**ADDENDUM NO. 03**  
**February 16, 2022**

To Drawings and Specifications dated February 2, 2022.

**FRIENDSWOOD HIGH SCHOOL ADDITIONS & RENOVATIONS**  
**FOR FRIENDSWOOD I.S.D.**

Prepared by: PBK  
11 Greenway Plaza, 22<sup>nd</sup> Floor  
Houston, TX 77046-1104  
PBK Project No: 20381

# A-306

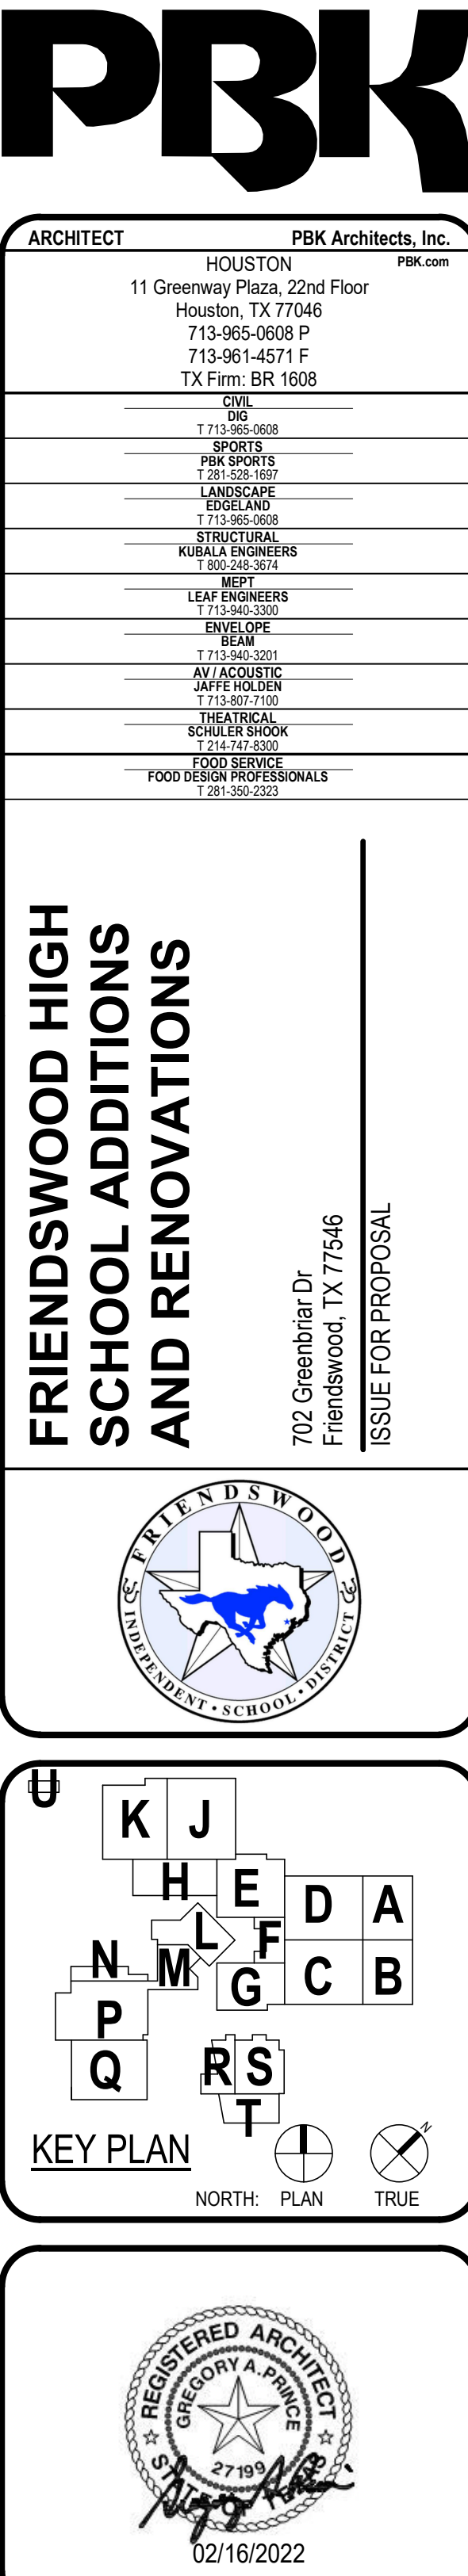
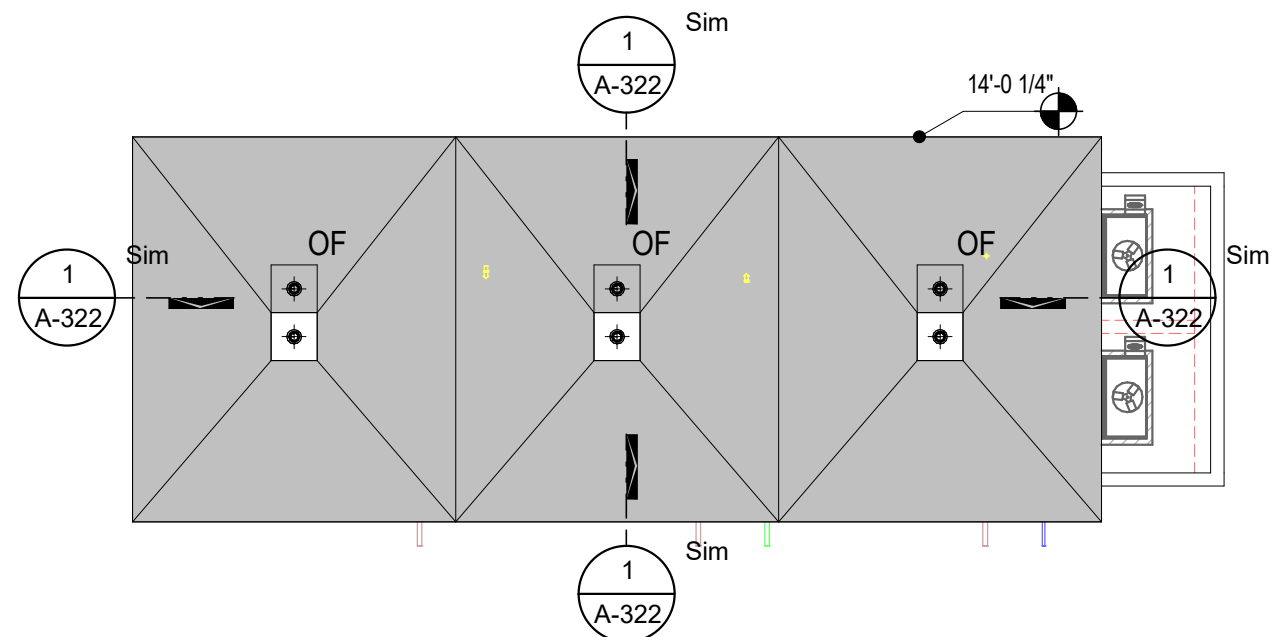
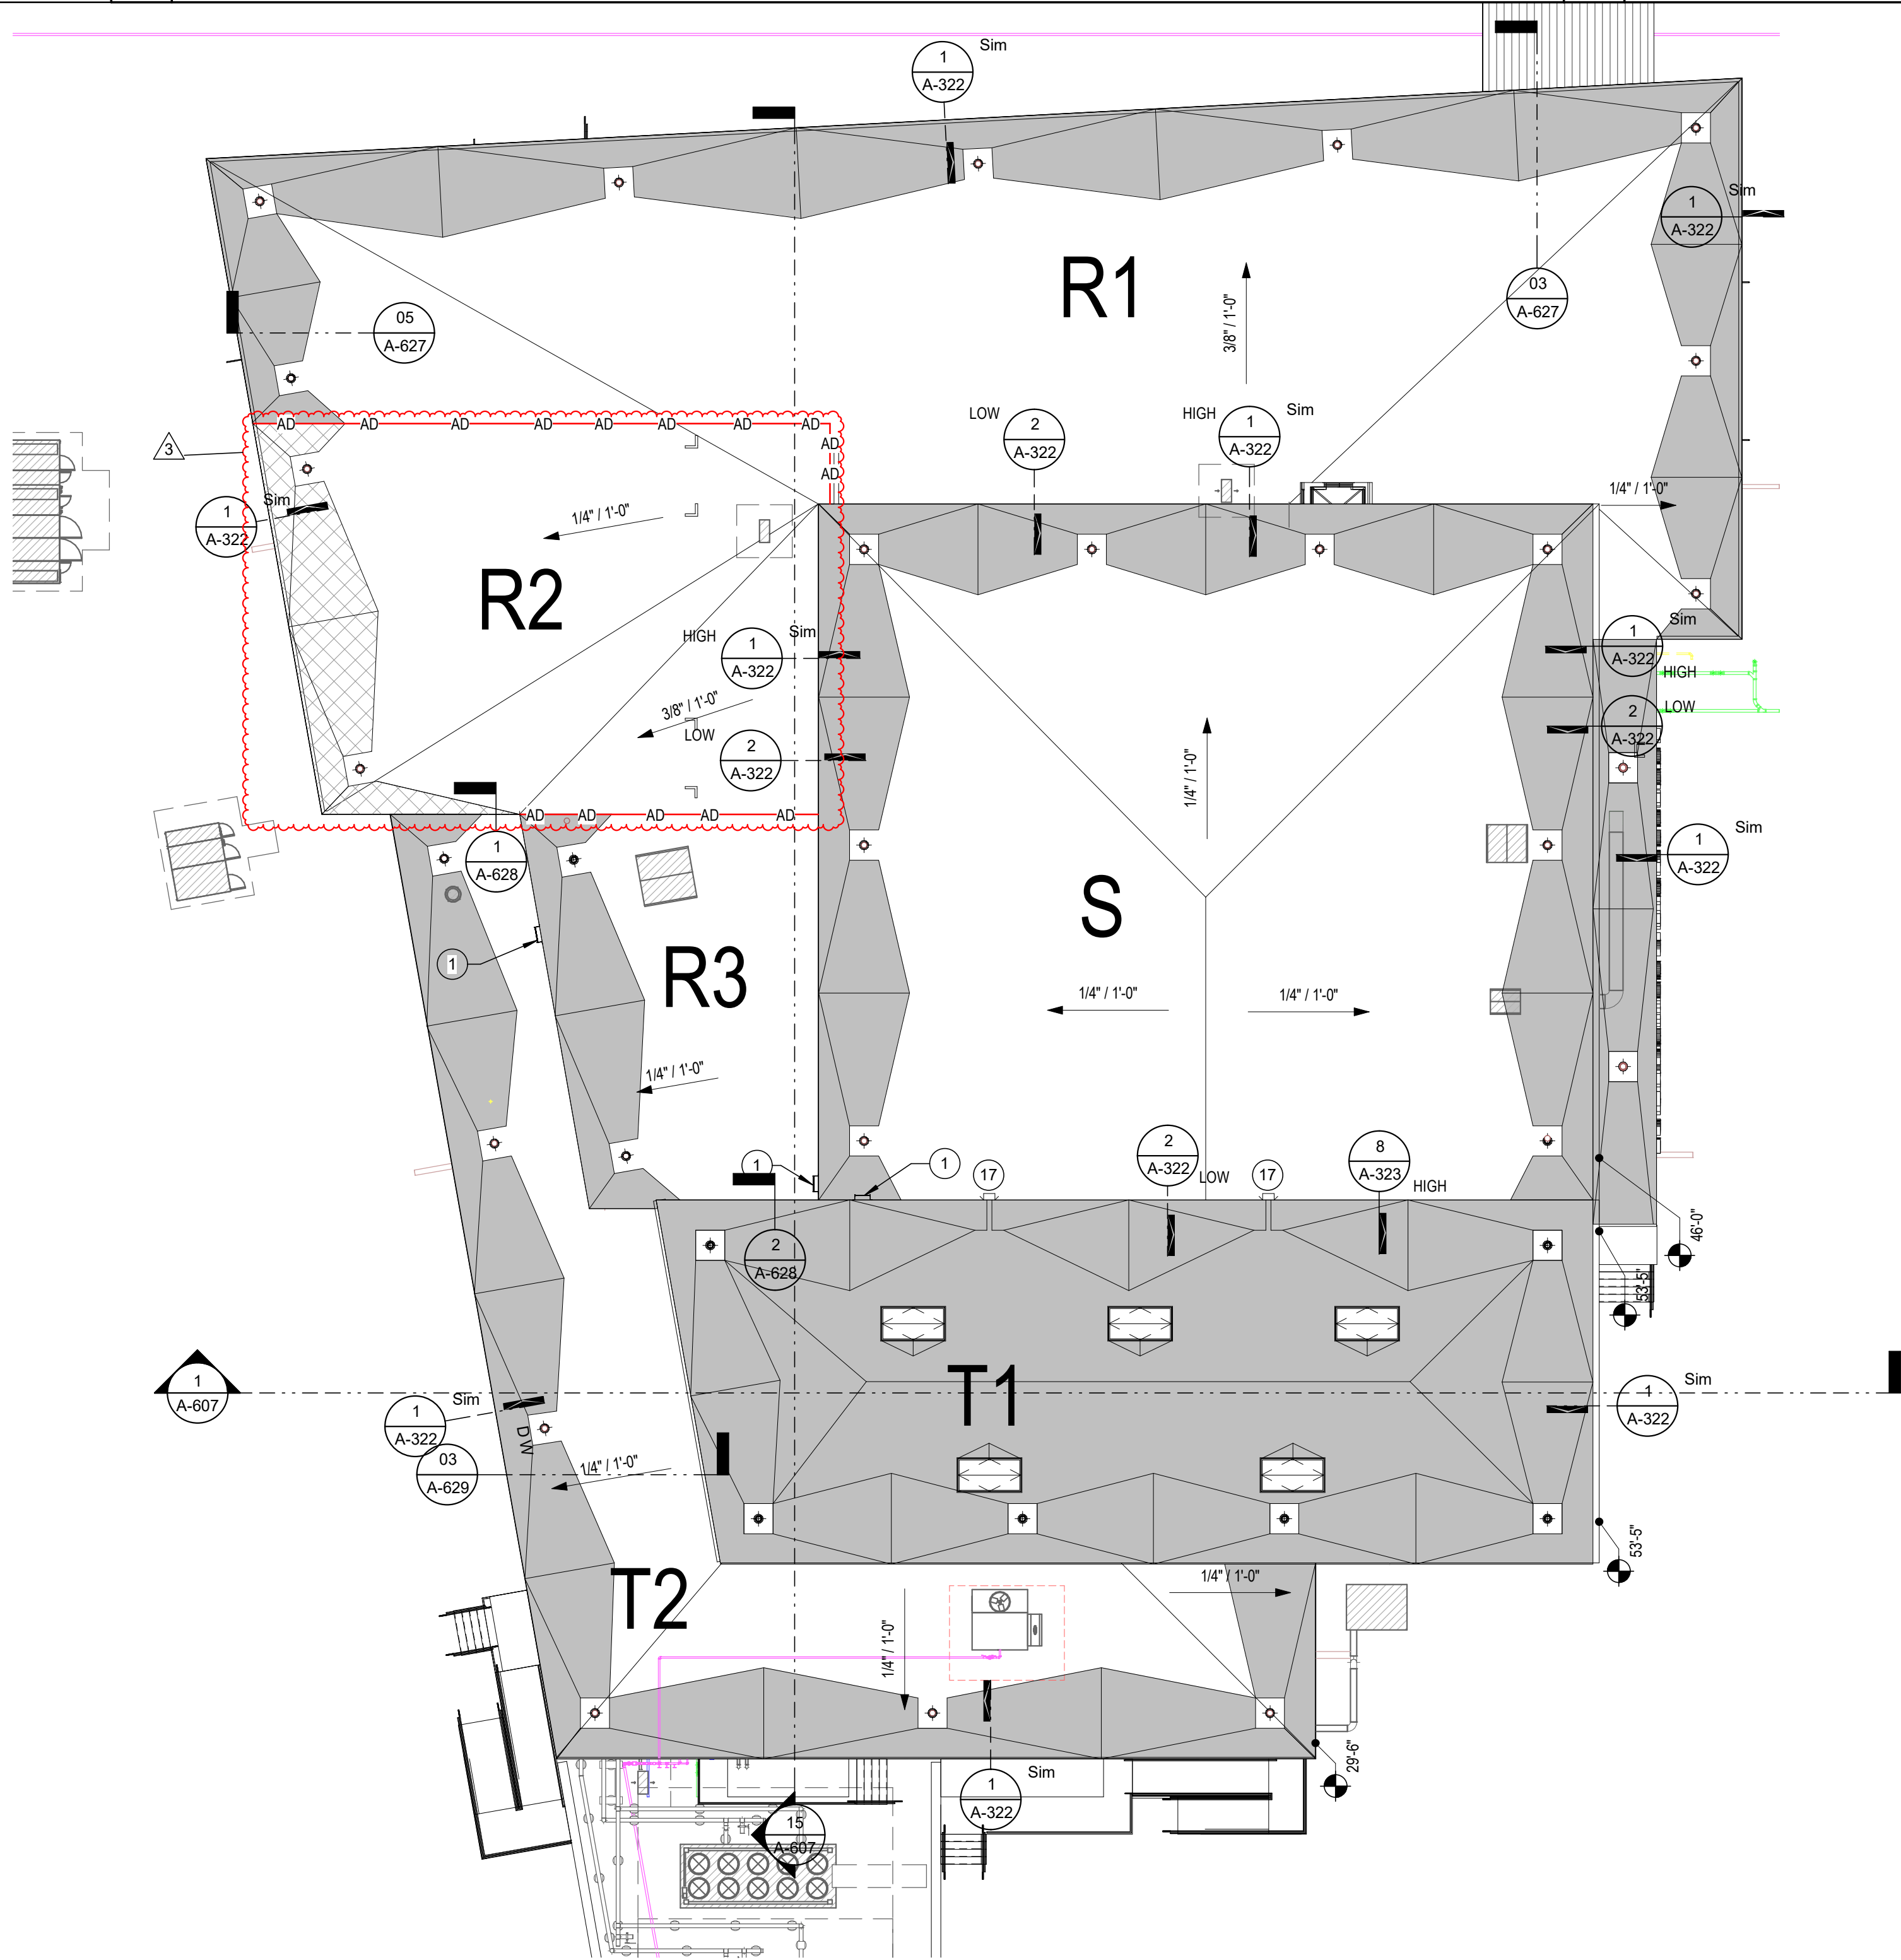
- Item No. 42 **On page A-306 cut through 10/A-604 at the junction of roofs P1 and Q1 (different elevations) shows a roof-to-wall expansion joint detail, however detail 20/A-322 also shown shows a roof-to-roof expansion joint. Please advise.** Answer: Detail tagged incorrectly. Refer to 3/A322. Refer to revised A-300 series drawings.

SK-03

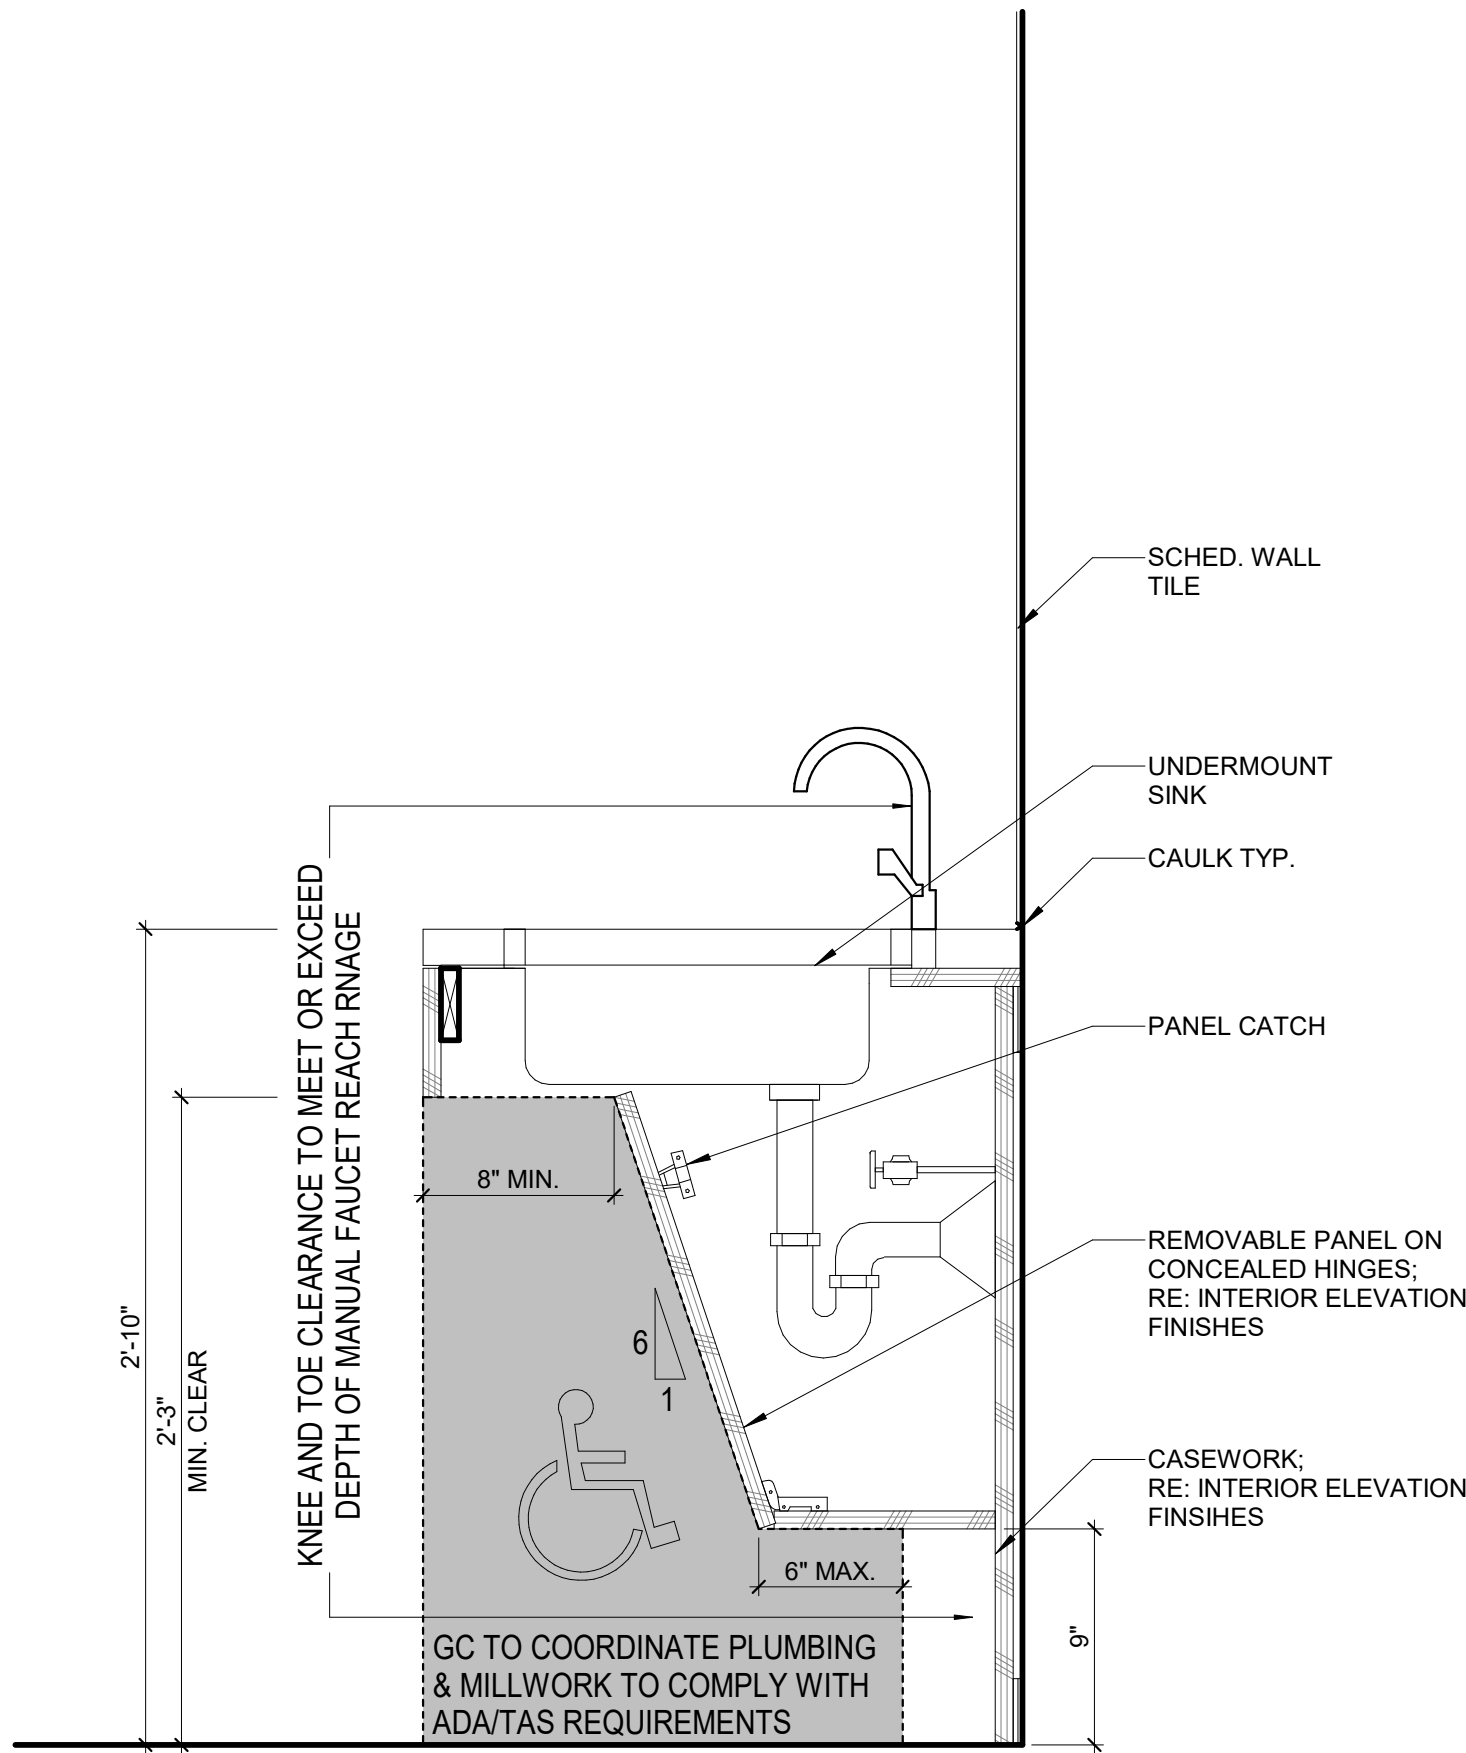
- Item No. 28 **Sheet A-517:** Add sheet in its entirety.
- Item No. 29 **Sheet A-623:** Replace sheet in its entirety.
- Item No. 30 **Sheet A-625:** Replace sheet in its entirety.
- Item No. 31 **Sheet A-842:**  
a) Add overhead door at 09/M102 Concessions South elevation. Refer to SK-03.  
b) Revise Locker Type C size to be 12" W x 18" D x 72" H.  
c) Revise Locker Type D to be single tier. Provide 4" concrete curbs under Locker Type D.
- Item No. 32 **Sheet A-845:** Replace sheet in its entirety.
- Item No. 33 **Sheet A-847:** Add sheet in its entirety.
- Item No. 34 **Sheet AF101:** Update exterior finish schedule to match exterior finish material legends. Refer to SK-04.
